Wisconsin Department of Transportation

Proposal #36: 7220-01-71, WISC 2015 150
C Menomonie, Broadway Street
24th Avenue – 11th Avenue
STH 25
Dunn County

Letting of March 10, 2015

This is Addendum No. 1, which provides for the following:

Addendum No. 1
ID 7220-01-71
Revised Sheet 24
March 4, 2015

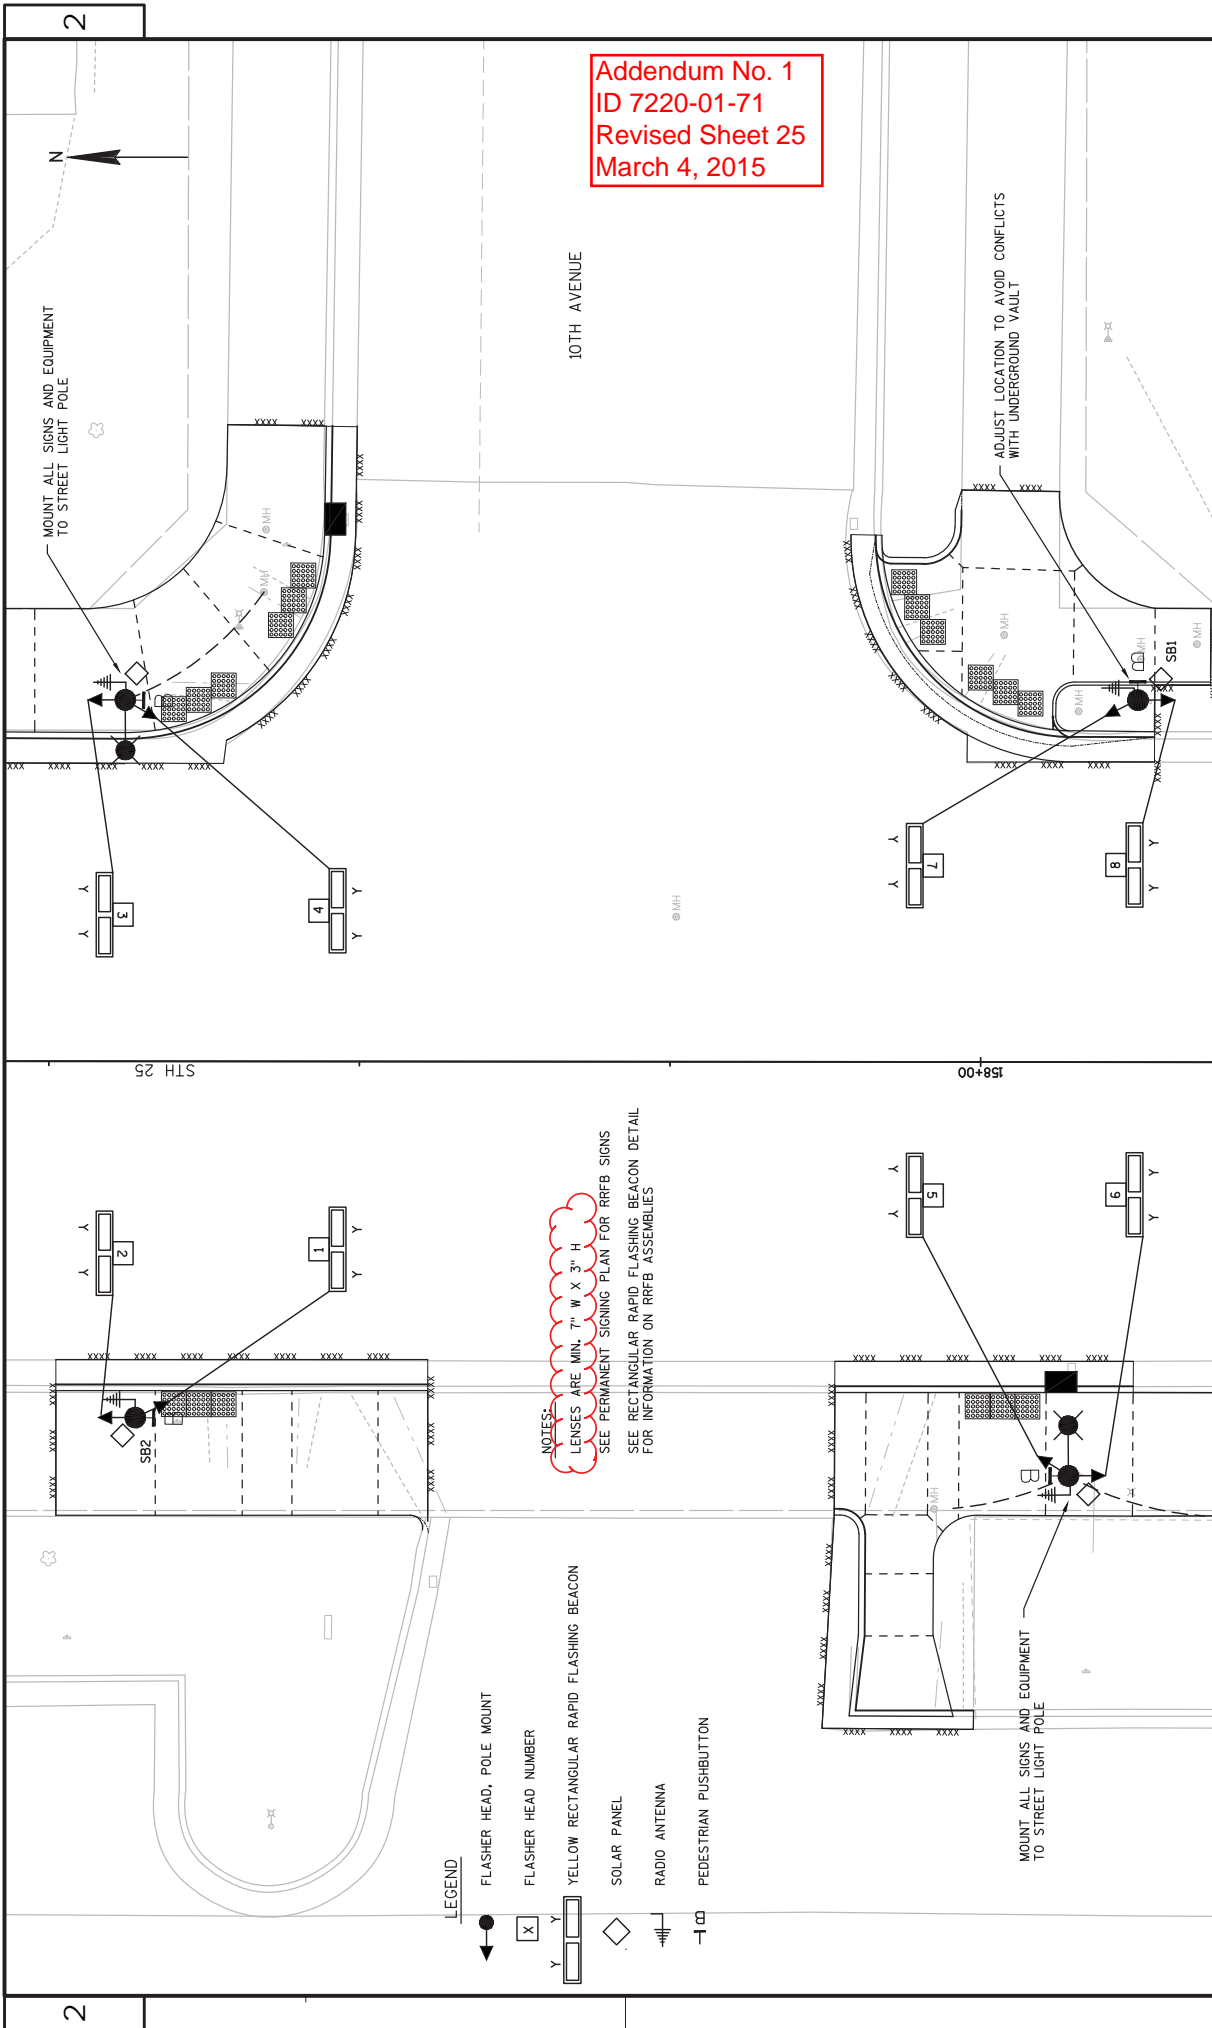
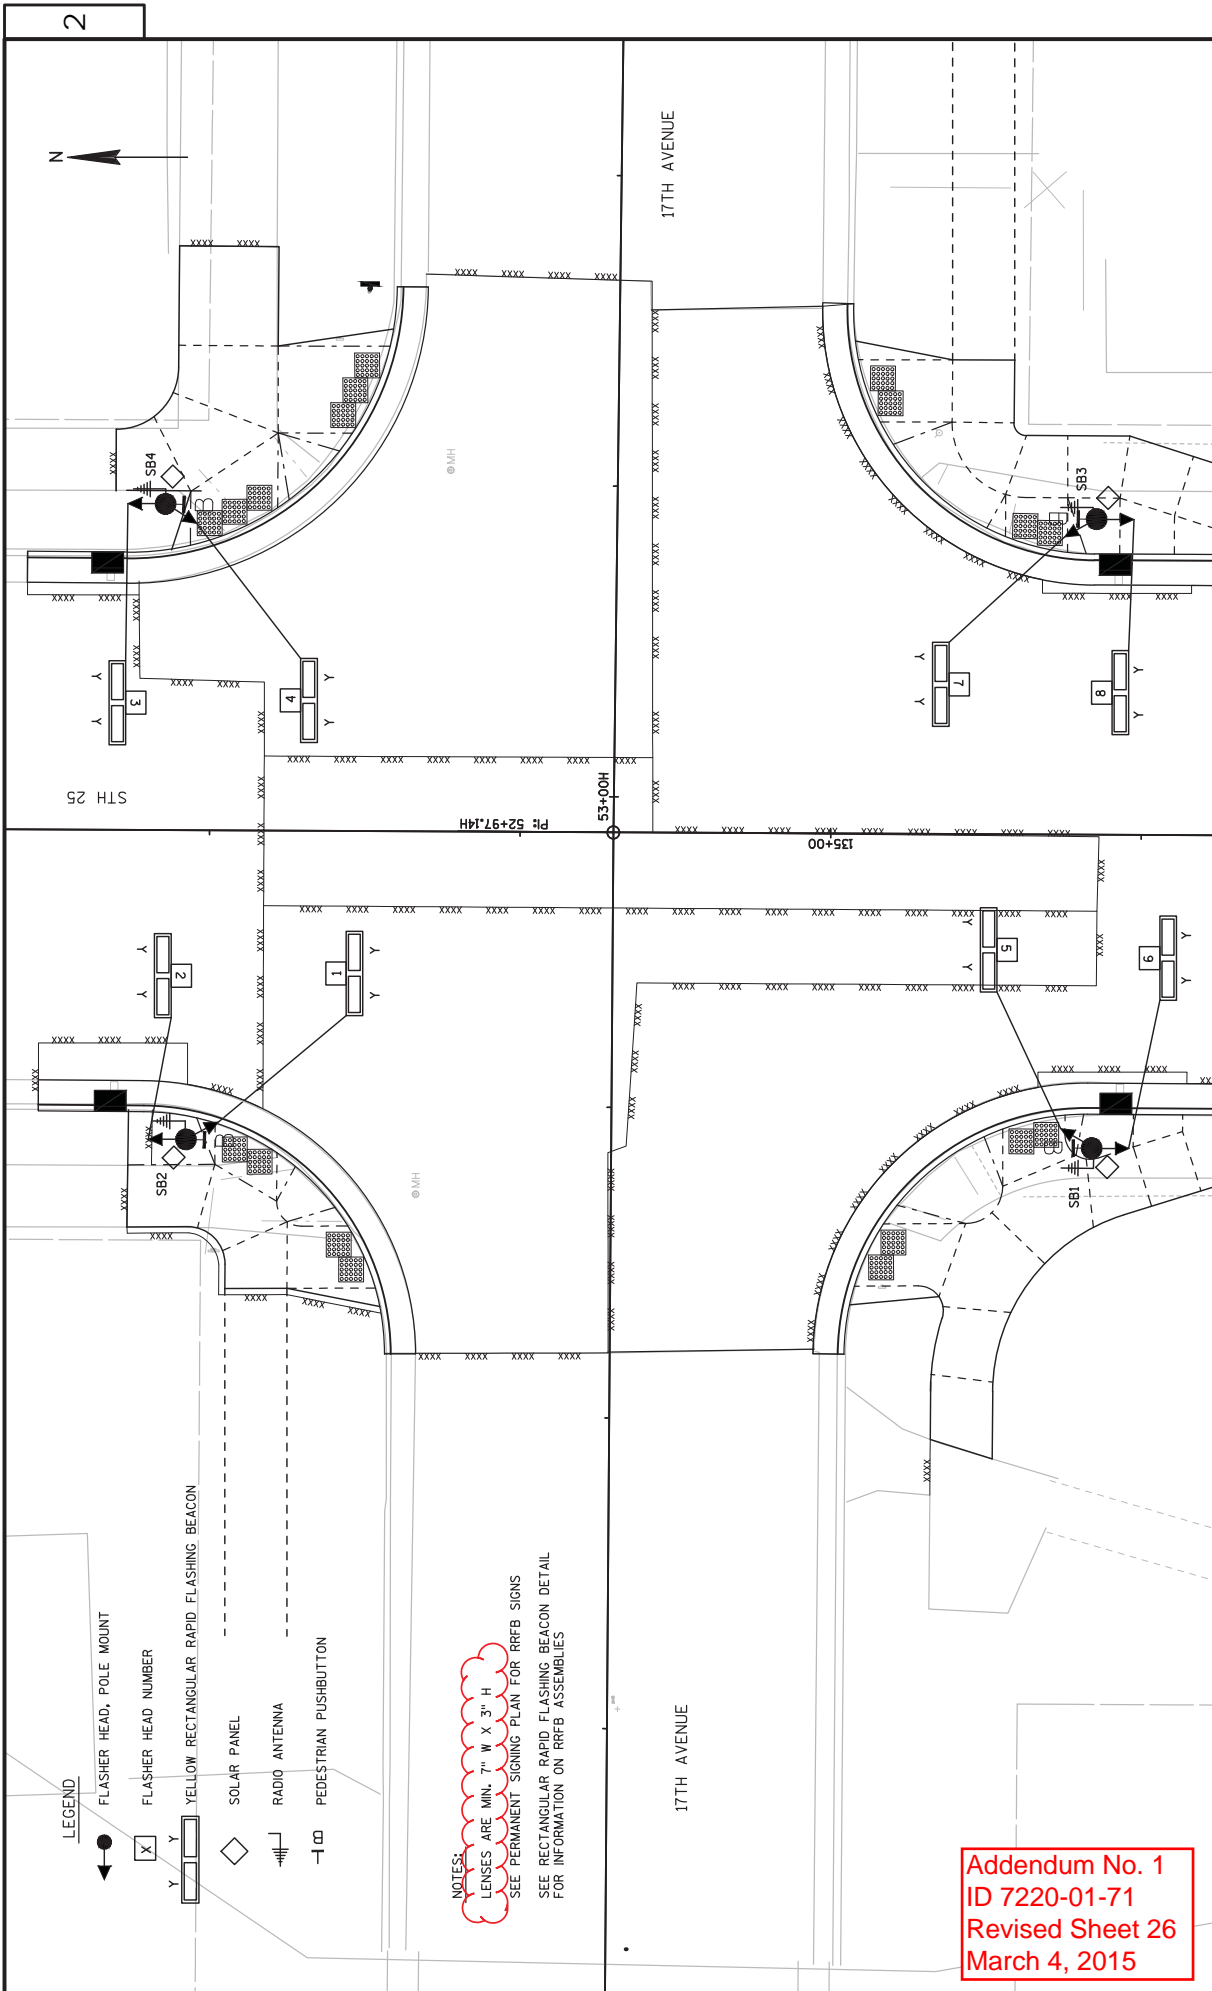
Revised Plan Sheets	
Plan Sheet	Plan Sheet Title (brief description of changes to sheet)
	ID 7220-01-71
24	Rectangular Rapid Flashing Beacon Detail (Note Change)
25	Rectangular Rapid Flashing Beacon 10 th Avenue(Note Change)
26	Rectangular Rapid Flashing Beacon 17 th Avenue(Note Change)
95	Miscellaneous Quantities(7220-01-71) (Quantities Change)
	ID 7600-02-71
34	IH 94 Alternate Route Signing (Note Changes)
35	IH 94 Alternate Route Signing (Note Changes)
36	IH 94 Alternate Route Signing (Note Changes)
37	IH 94 Alternate Route Signing (Note Changes)
52	Miscellaneous Quantities (Quantities Change)
53	Miscellaneous Quantities (Quantities Change)

Addendum No. 1
 ID 7600-02-71
 Revised Sheet 34
 March 4, 2015

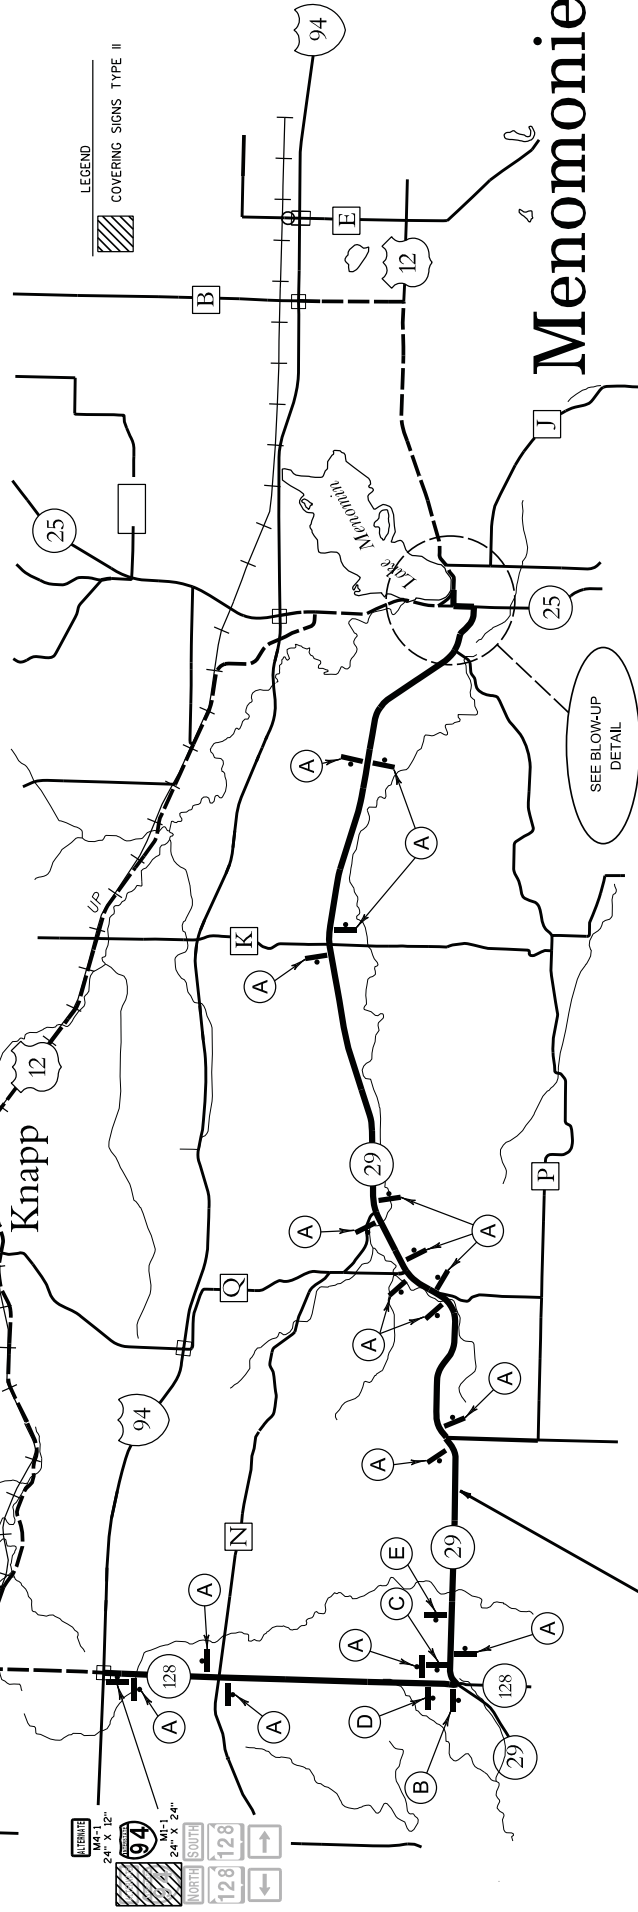
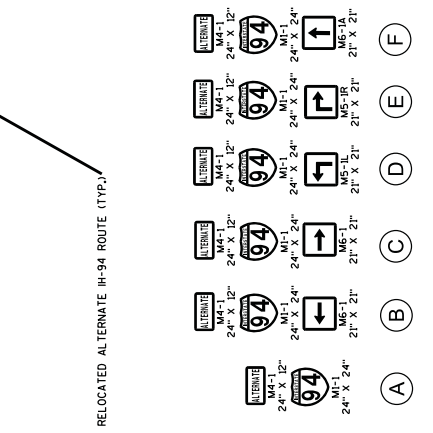
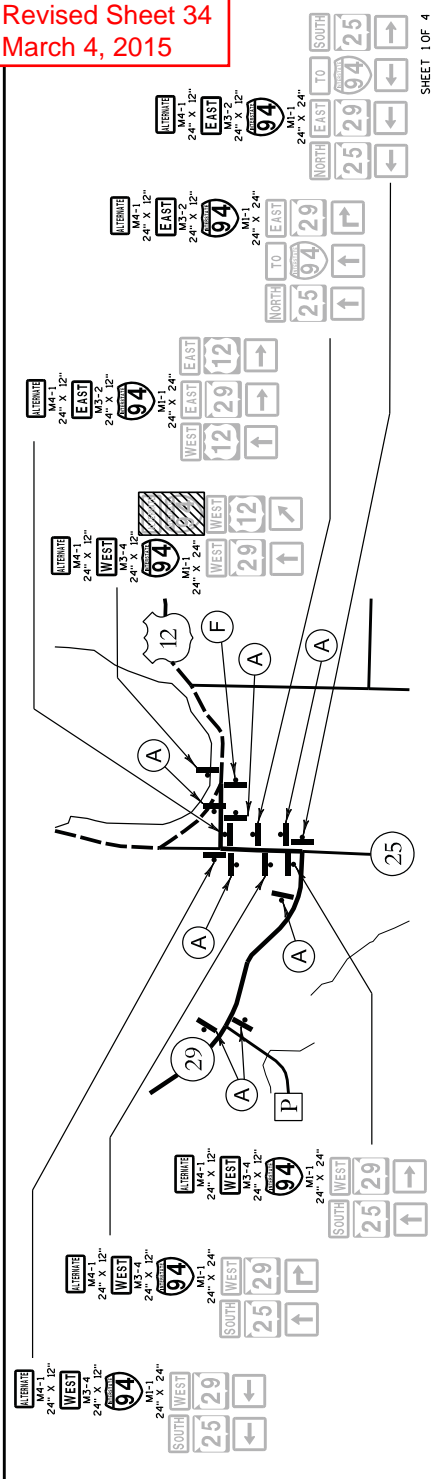
55. Alternate Route Signing Coordination with Other Project.

The Department plans to mill and pave, replace culverts, replace beam guard and resign on the following project 7090-05-65 located on USH 12 within the 2015 Construction season with 7220-01-71, 7600-02-70 and 7600-02-71 Concrete pavement repair, signals and utilities projects located on USH 12 and STH 25:

Contact the Department and the contractor for the project 7090-05-65 to obtain schedule of beginning construction to coordinate placement of the alternate route signing for IH 94 on STH 29 and sign covering on USH 12 within the project limits prior to the start of construction operations..
